**ASSESSMENT REPORT 15**

# **McARTHUR RIVER PROJECT**

## **PROPOSED ZINC-LEAD-SILVER MINE**

### **ENVIRONMENTAL ASSESSMENT REPORT**

## BARGE LOADING FACILITY DETAIL

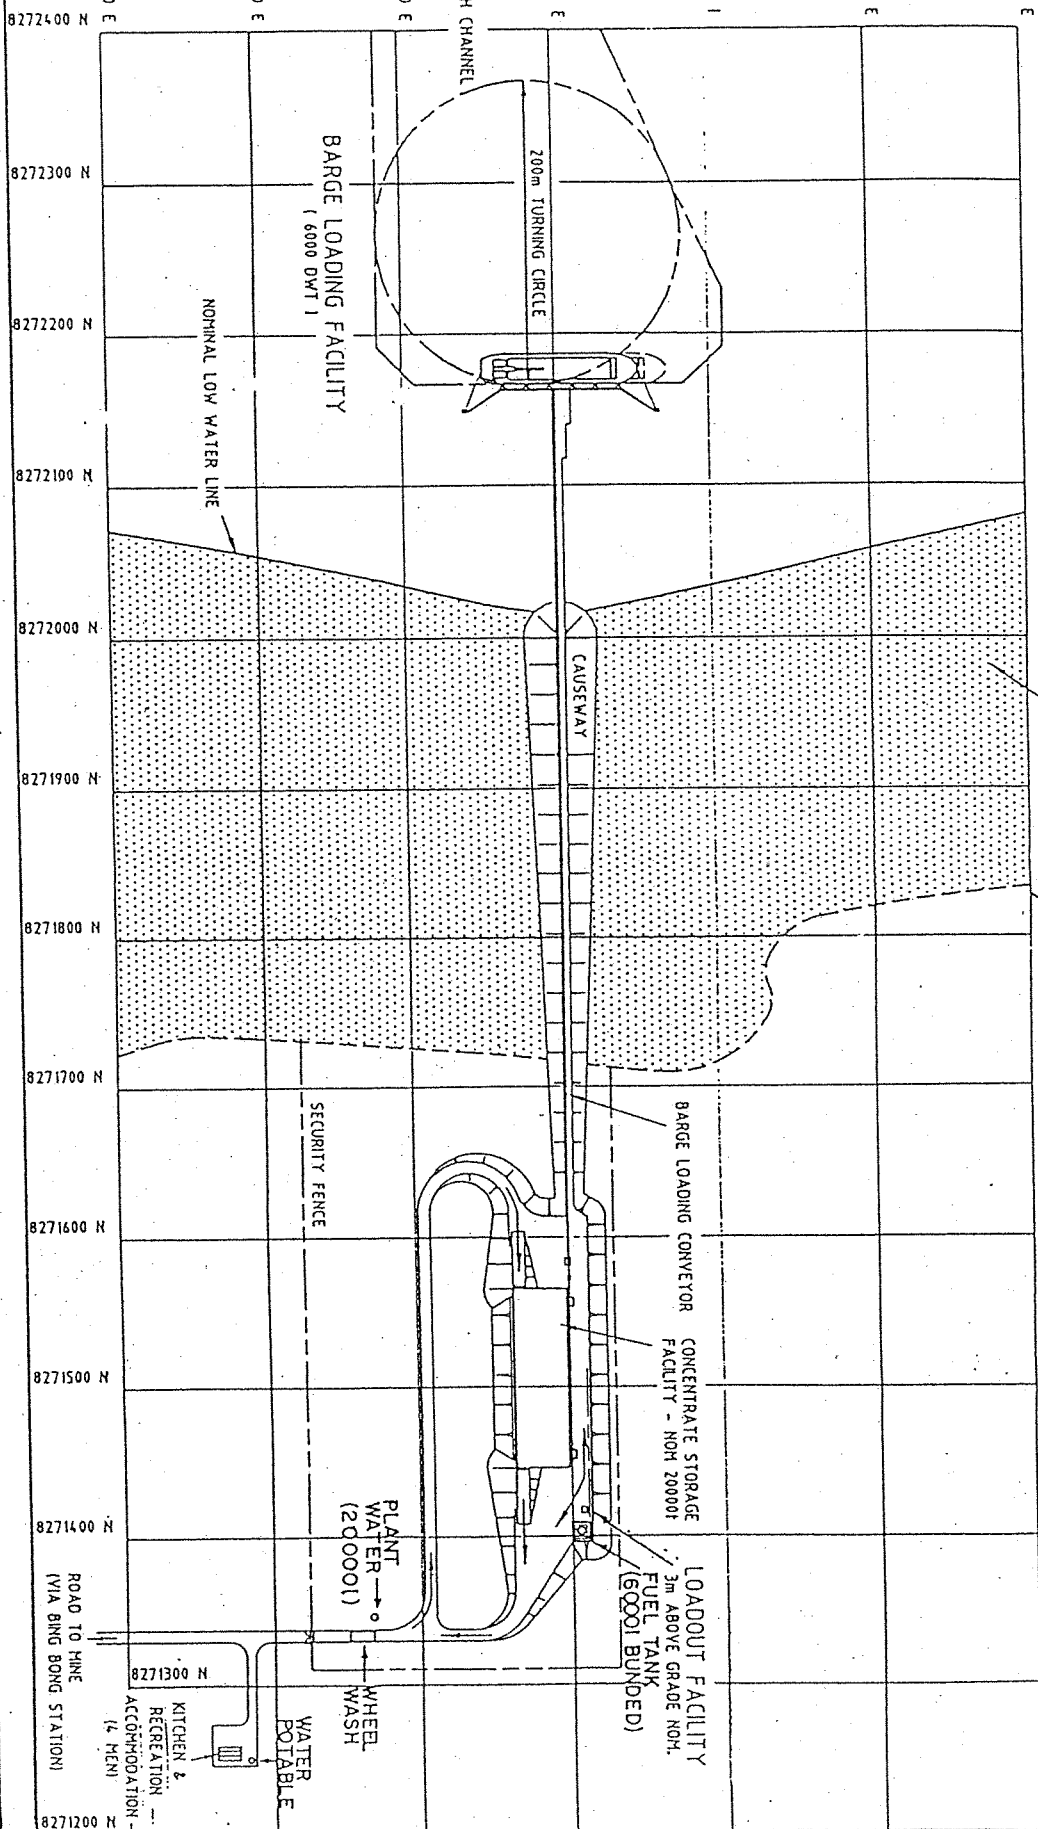
The barge loading facility is proposed to be located approximately 4 km east of the homestead near Mule Creek and will comprise a covered storage facility, where up to 30,000 tonnes of concentrate can be stored prior to loading on the barge (**Figure 3**).

The proposed causeway to the barge loader was identified as having the potential to upset the equilibrium dynamics of longshore sediment transport processes, with associated effects on Little Tern breeding areas some 20 km northwest of the facility. Although there is a considerable volume of potentially mobile sediment near shore, and the available evidence suggests long term progradation of the coastline, the vectors and rates of sediment dynamics are not known. The comparison of aerial photographs for the period 1943 - 1984 may not show the long term trends, because long term low energy processes may be interrupted by storm events. For example, the effect of Cyclone Kathy in March 1984 on offshore dune morphology may not have been accounted for in the interpretation of sediment patterns (presumably the photography was flown post-cyclone).

Although the proponent has not determined the final configuration of the causeway and trestle, the design shown in the DEIS (Vol.1, Figure 3.8.3) is preferable to that shown in the Supplement (Figure 41.3).

The use of dredge spoil as foundation material for the causeway and stockpile facility may not be advisable if there is any uncertainty regarding its engineering suitability. It is considered more prudent to utilise available resources of known geotechnical characteristics on Bing Bong Station. Borrow pit design on the site designated for extraction in Figure 41.5 of the Supplement will need to meet the additional requirements for settling ponds and associated structures if the disposal of dredge spoil is to be accommodated there - see Section 4.3 on dredging.. Although no estimate of pit dimensions or extraction volumes was given in the Supplement, the hatched area in Figure 41.5 suggests an area of about 25 ha will be used. The 760 000m<sup>3</sup> of dredge spoil will cover this area to a depth of at least 3m. Consequently, the guidelines applicable to roadside borrow pits are not considered appropriate, and the proponent will need to provide design details and engineering criteria for the borrow pits/dredge spoil ponds. Refer to 4.3 for recommendations.

There is the potential for chronic emissions occurring via plant and equipment wheels and lower body structures. This includes front end loaders which may move between the stockpile and other parts of the facility. The location of the wheel wash facility as shown in Figure 3.8.3 of the DEIS is inappropriate, as significant deposition of wheel-borne dust is possible outside of the building before the wheel wash.

There is a risk of emissions along the causeway or at the berth head due to plant traffic from the barge to the stockpile facility, especially when front end loaders from the barge are disembarked. Consequently, a wheel and lower body wash system needs to be installed on the barge. Wash water and sediment will need to be contained on board for disposal to future shipments.

(ii) A wheel and underbody wash system should be used at all plant exiting points for the stockpile building to prevent concentrate emissions;

A wheel and lower body wash facility should be used on the barge prior to disembarking of plant and equipment. The sediment and wash water should be contained onboard for disposal to future concentrate shipments as a dust control measure.
